**Subject: SLIC Case No. RO0002892, Chevron Sunol Pipeline, 2793 Calaveras Rd, Sunol, CA
Response to April 4, 2013 Regulatory Letter—Technical Comments and Data Gap
Investigation Report Addendum**

Subject: Case File Review for SLIC Case No. RO0002892 and GeoTracker Global ID SL0600100443,
Chevron Sunol Pipeline, 2793 Calaveras Road, Sunol, CA 94586

DATA GAPS INVESTIGATION AND REMEDIATION ADDENDUM

FIGURE F-1

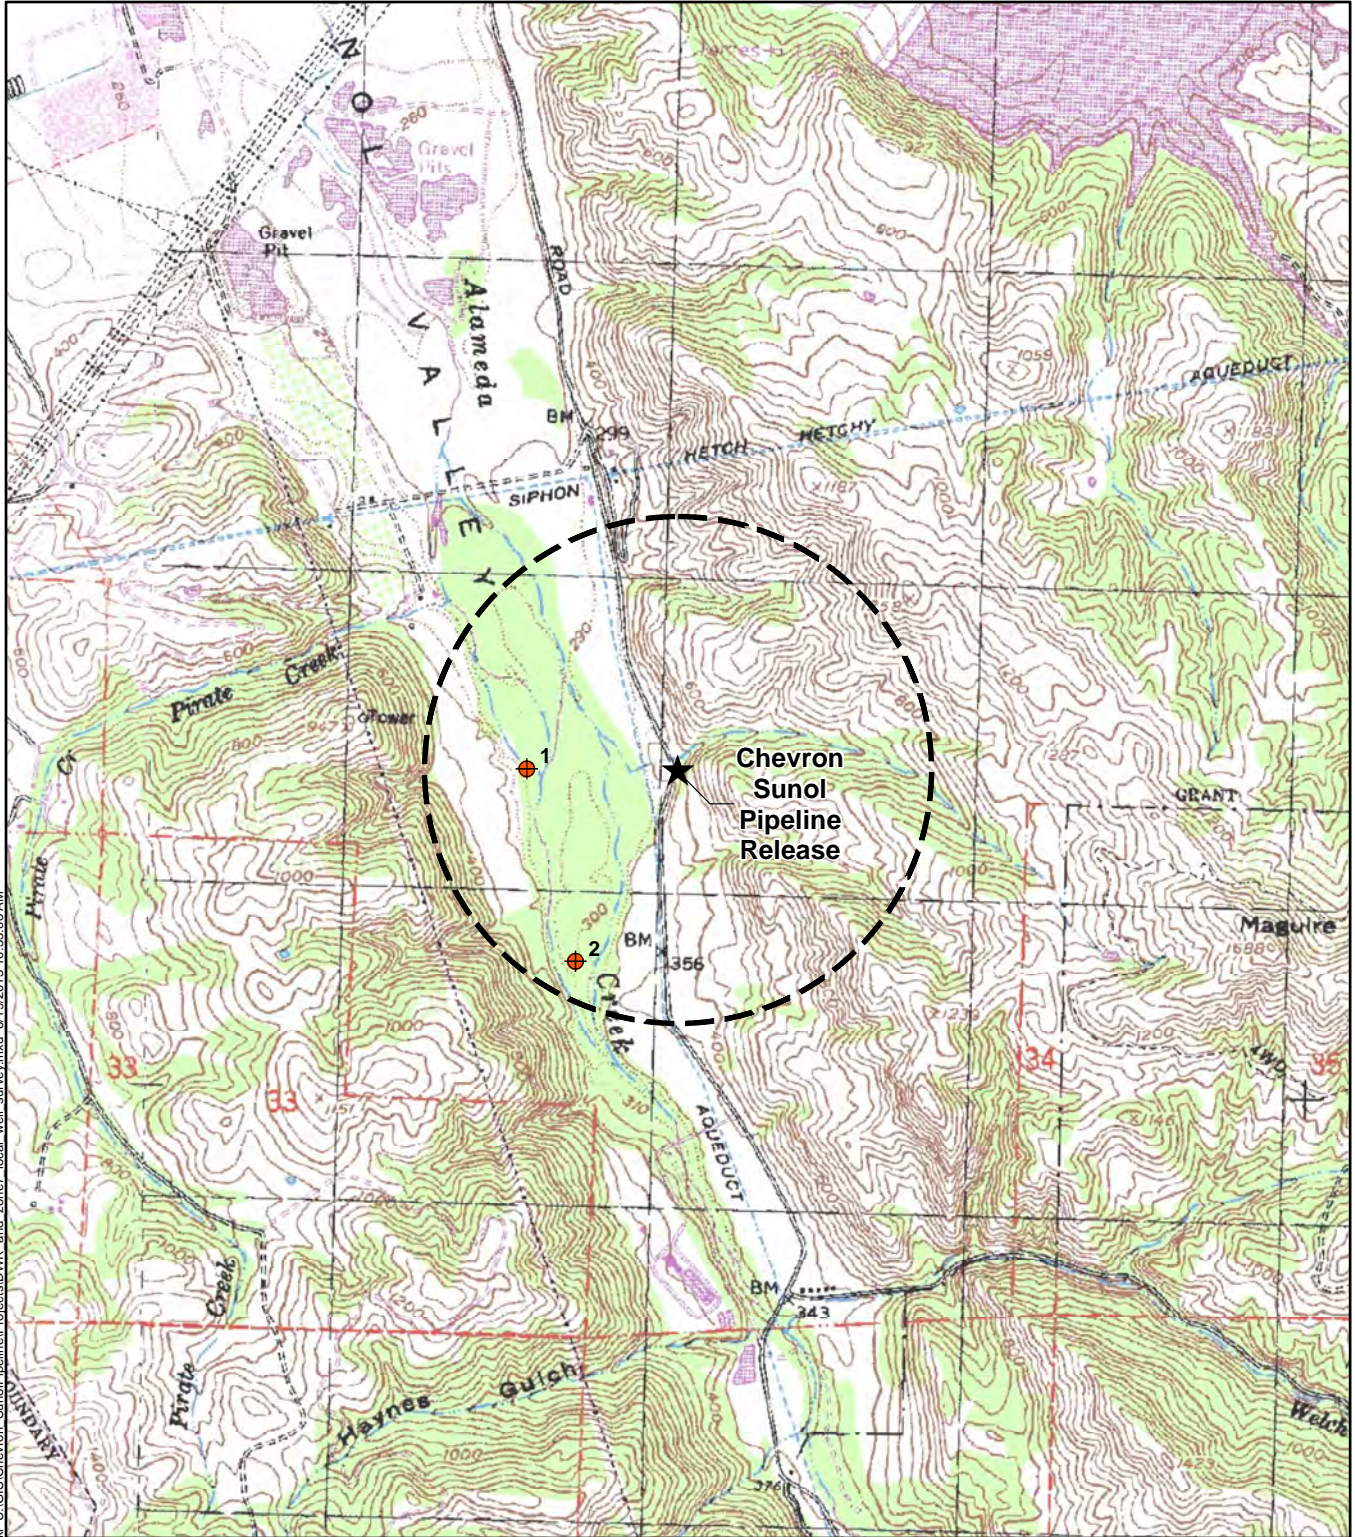
Vapor Extraction Wells on Figure F-1 of Well Survey Data. Figure F-2 in Appendix F shows two vapor extraction wells in Alameda Creek. The wells were installed in August 2007 and the well owner is the San Francisco Public Utilities Commission. Please provide any additional information available regarding the purpose and use of these wells.

- 3. Monitoring Wells on Figure F-2 of Well Survey Data.** Figure F-2 in Appendix F of the Report shows several monitoring wells near the site and west of the site. However, the base map is at a scale of 1 inch equals 1,200 feet and it is not clear whether all of the wells shown in the area of Calaveras Road are monitoring and vapor extraction wells installed for this site. The Report indicates that Figure F-2 shows groundwater monitoring and soil vapor extraction wells for the CPL Sunol site. However, several of the monitoring wells are shown at greater distances from the Calaveras Road than the monitoring wells installed for the site. In the Site Investigation Report requested below, we request that you present a revised Well Survey Results section that includes a revised Figure F-2. Figure F-2 should be revised by providing a more detailed base map that clearly identifies and differentiates all site wells and any other monitoring wells that were not installed for the CPL Sunol site. The Well Survey Results section of the Report should be revised to provide available information on any monitoring wells that are not site wells and to evaluate whether any of these wells could potentially be used to verify plume extent.

4. **Vapor Extraction Wells on Figure F-1 of Well Survey Data.** Figure F-2 in Appendix F shows two vapor extraction wells in Alameda Creek. The wells were installed in August 2007 and the well owner is the San Francisco Public Utilities Commission. Please provide any additional information available regarding the purpose and use of these wells.

URS agrees that Figure F-2 provided by Zone 7 is not the same scale as the URS provided Figure F-1. This makes comparison between the two figures difficult. URS has contacted Zone 7 and received the coordinate information for the wells located within a ½-mile radius of the site, and has included this information in the updated Well Survey Results section, table, and new Figure F-1 in Attachment B.

The two wells identified in Appendix F, URS Table F-1, were misrepresented as vapor extraction wells. Further review of the California Department of Water Resources (DWR) Well

Completion Reports shows that the wells previously described as vapor extraction wells are actually piezometer wells. URS contacted SFPUC for more information regarding the purpose and use of the piezometer wells but did not receive a response. It is known that these wells are in part of the Hetch Hetchy water supply monitoring and conveyance system. Further review of the DWR Well Completion logs and the lack of information indicating well location, as well as the additional information received from Zone 7, the wells identified by Zone 7 are the same wells as previously identified by DWR. Based on the coordinate information received from Zone 7, the local well survey results shown on Figure F-1 have been replotted approximately 780 feet (well 1) and 140 feet (well 2) further west of the Site. As such, the attached addendum section only includes new Figure F-1 showing the locations of the DWR and the Zone 7 wells (Attachment B).

Based on the dimensions of the hydrocarbon plume, and the locations and distances to these wells, it is not likely that the piezometer wells could be impacted by the hydrocarbon plume at the Site. Well survey data is presented in Table F-1 and locations are depicted on Figure F-1 (Appendix F).
